## STAFF REPORT AND RECOMMENDATION ON APPEAL

APPEAL NO.: A-6-CII-03-26

PROJECT DESCRIPTION: Demolition of an existing single-family dwelling and construction of a two-story, 30-foot high, 6,358 sq.ft. single-family dwelling with basement, attached 700-sq.ft garage/storage, roof deck, swimming pool and spa. In addition, the project includes the removal of an existing unpermitted wooden bulkhead, wooden return walls, and revetment rocks and construction of a new 50 ft. long, 18 ft. high vertical seawall on two 3,500 sq. ft. oceanfront lots proposed to be merged in one 7,000 sq. ft. lot.

PROJECT LOCATION: 2649 Ocean Street, Mello II, Carlsbad (San Diego County)  
APN 155-104-04

**EXHIBIT NO. 2**  
**APPLICATION NO.**  
**A-6-CII-03-026**  
**Site Plan**

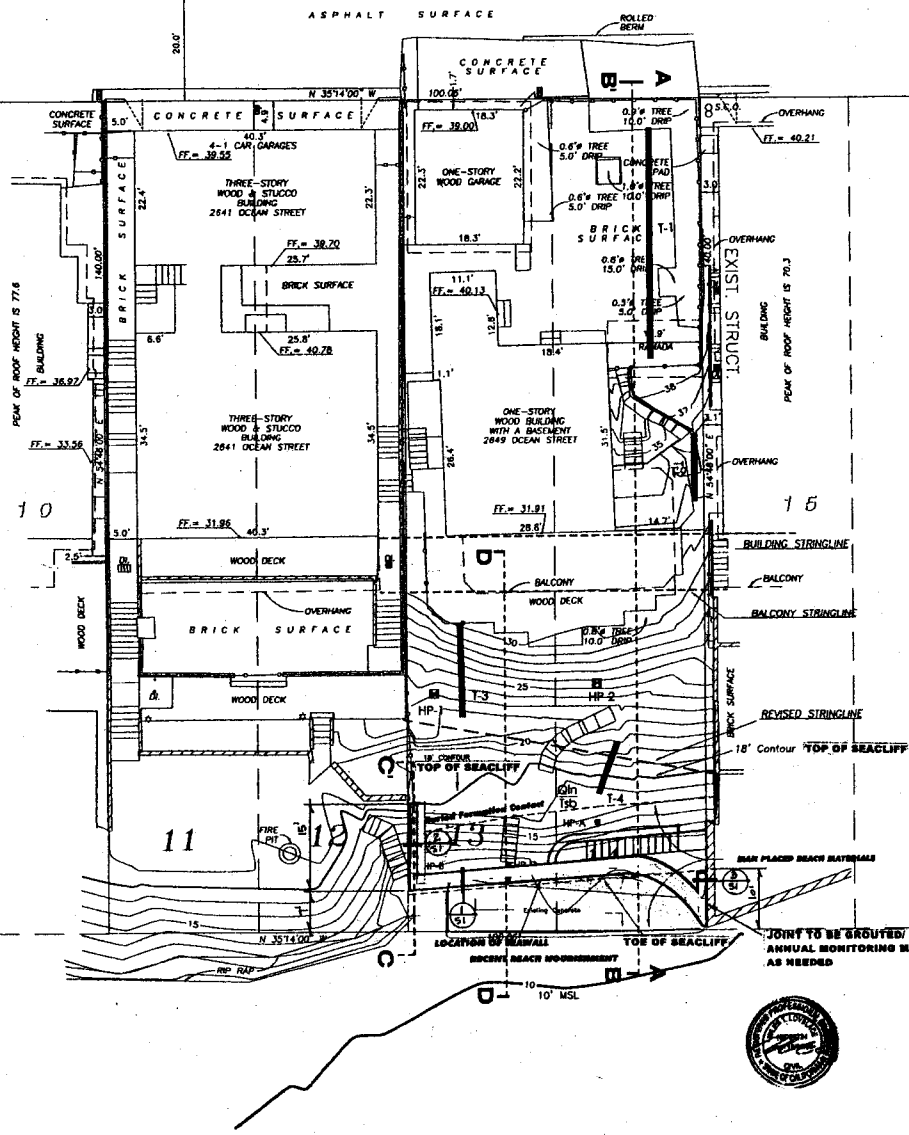
Exhibit 2, Sheet 1 depicts the location in plan view of the proposed 18-foot high seawall in relation to the toe of seacliff, westerly Kiko property line, seaward beach sand level, and existing wooden bulkhead and return walls on the site topographical base map.

Along 39 feet of its length, starting at the northwesterly Kiko property corner, the westerly edge of the seawall is proposed to be located immediately behind (landward of) the mapped toe of sea cliff (coastal bluff), which results in a setback from the westerly property line of ~7 to 9.5 feet and a proposed public lateral access area behind the present back beach of 387 square feet. (See Section 2.3.4.) A small private stairway to access the beach at existing sand profile elevations is proposed to be located to landward and below the top of the wall, as shown on Sheet 1. Along the southerly (downcoast) ~11 feet length of the proposed seawall, it necessarily curves toward the southwest to join the nearest edge of the vertical seawall on the adjacent downcoast property. An even steeper curve, or a 90-degree corner, where the wall meets the adjoining downcoast 18-foot high sea wall, would likely result in accelerated beach scouring during combined high tide-large storm events, due to increased wave reflection and refraction, and was therefore rejected by the project engineers. Return walls, 10 and 15 feet in length, are proposed, respectively, along the southerly and northerly property lines to further protect against potential flanking erosion.

- a. Elimination of the proposed seawall, the backfill behind the seawall and the swimming pool.

EXHIBIT NO. 6  
APPLICATION NO.  
A-6-CII-03-026  
Section

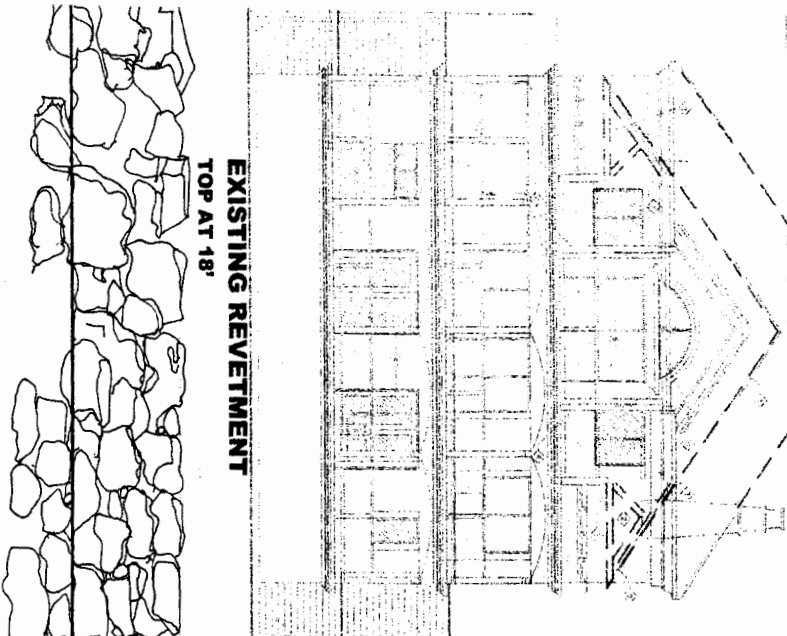
Landward of the covered shade deck and the sun deck, the applicant is proposing to construct a pool and spa. Sheet A7 shows that the pool and spa will extend approximately 24 feet seaward of the residence. The outer (seaward most) pool wall will be approximately 16 feet from the identified 18-foot contour, the approximate location where the bluff steepness markedly increases seaward. Sheet A4 (undated) shows a plan view of the development with the 18-foot contour drawn onto the plan view. The spa is shown as a semi-circular feature near the northern lot line, and the pool is mostly rectangular, widening to the south in a step-wise fashion. In these plans, the spa is within 20 feet of the identified 18-foot contour and the pool is 24 to 28 feet from the 18-foot contour. The submitted plans do not show the foundation plans for either the spa or the pool, so the foundations for these structures may be further seaward than what is shown on either Sheet A4 or A7.

The annualized average retreat rate in this location is approximately 0.2 feet. Considering only erosion, the spa and pool would be setback far enough to be safe from the theoretical amount of erosion that would occur over a 75 year period ( $0.2 \text{ ft/yr} \times 75 \text{ yrs} = 15 \text{ feet}$ ). Such a setback would not provide any buffer nor make any accommodation for slope instability. In addition, erosion is more likely to occur during large storms, as episodic events. As noted by the applicant's coastal engineer, "The adjoining property to the south lost about 20 feet of the toe of the slope to erosion in the January-February, 1978 storms." (September 10, 2003 Letter Report from Skelly Engineers, page 2) The pool and spa are close enough to the 18-foot contour that under the no project alternative, they could be threatened by erosion and bluff retreat well before the 75 year time period.

While the proposed spa and pool may have a shorter term of economic viability than the proposed home, there may be adverse impacts to the coastal landform from installing and removing these structures. The plans do not show the foundation plans for these structures. These structures are often more difficult and disruptive to remove than planters, flat terraces or shallow foundation garden walls. Thus while the proposed spa and pool may be safe for their anticipated economic life, the removal of these structures at the end of their economic life may greatly disturb the coastal area seaward of the proposed home. The full life-cycle impacts of these structures should be considered and issues of removal need to be factored into the overall evaluation of how these structures could impact coastal resources.

EXHIBIT NO. 8
APPLICATION NO. <b>A-6-CII-03-026</b>
Proposed Seawall
California Coastal Commission

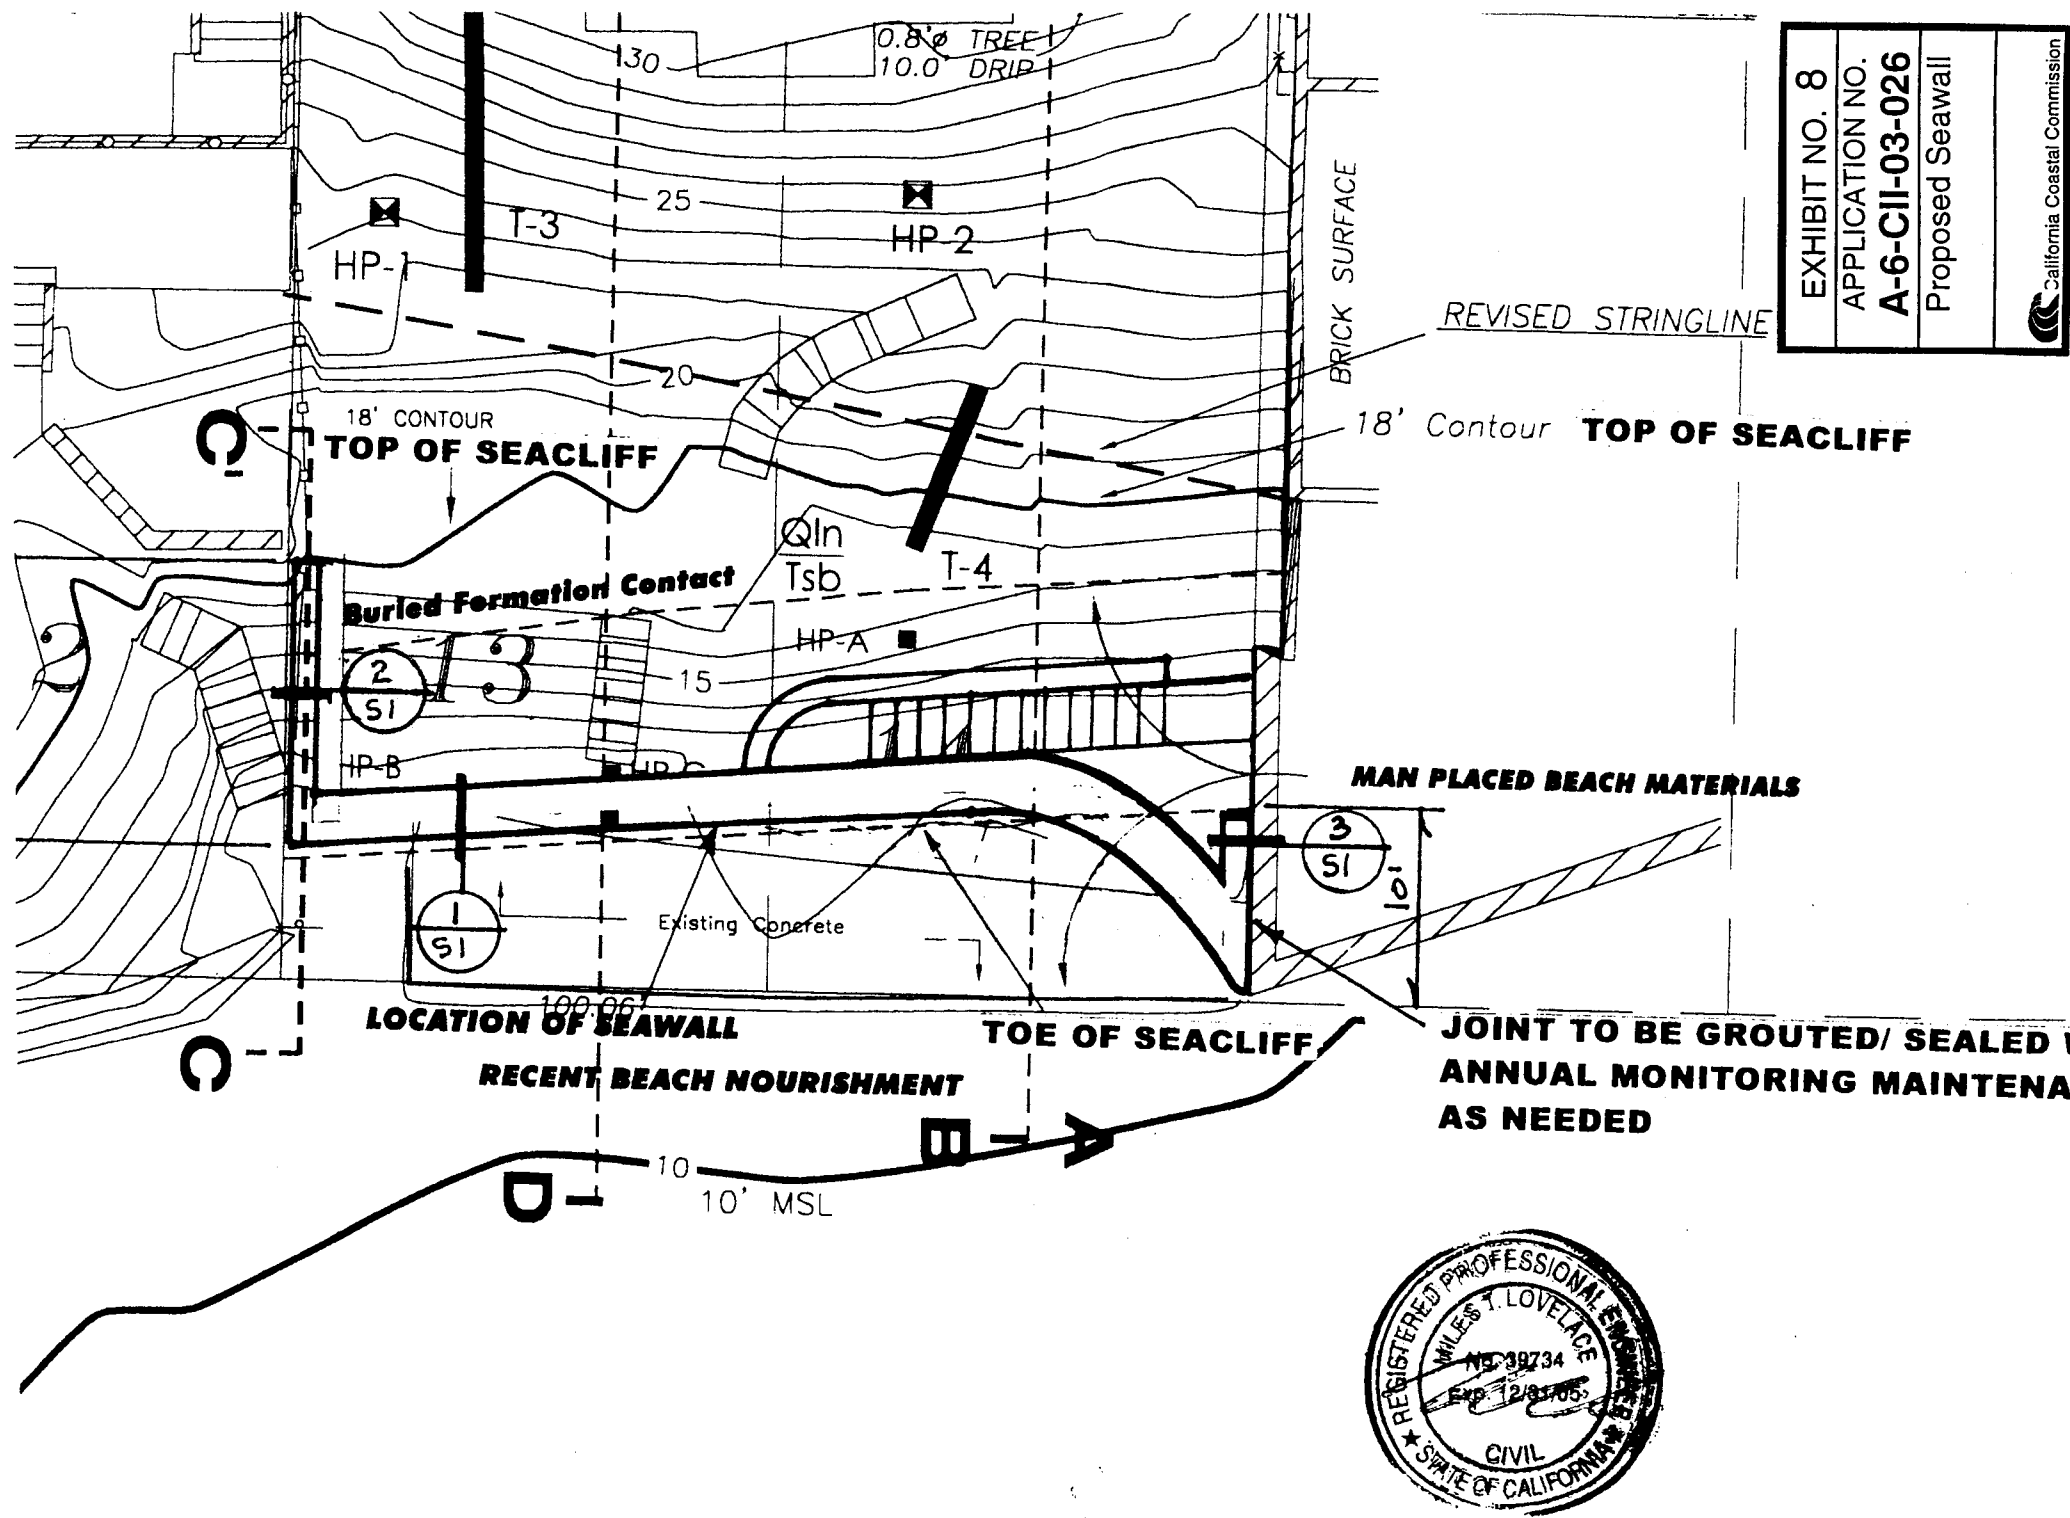
The applicant is proposing removal of the existing unpermitted wooden bulkhead in conjunction with reconstruction of a new seawall, however, neither the existing unpermitted wall nor the new proposed wall are necessary pursuant to Section 30235 and applicable LCP policies. The applicant is proposing to remove the unpermitted wall; however, in the event that the wall is not removed, this permit in no ways authorizes its retention in any way.

In response to concerns raised by Commission staff, the applicant analyzed the need for the seawall to address the concern that the adjacent properties will be subject to threat from erosion due to flanking of the protection that exists on those sites. The analyses found that the "no project", "upgrading the existing wooden bulkhead" and "Long-term
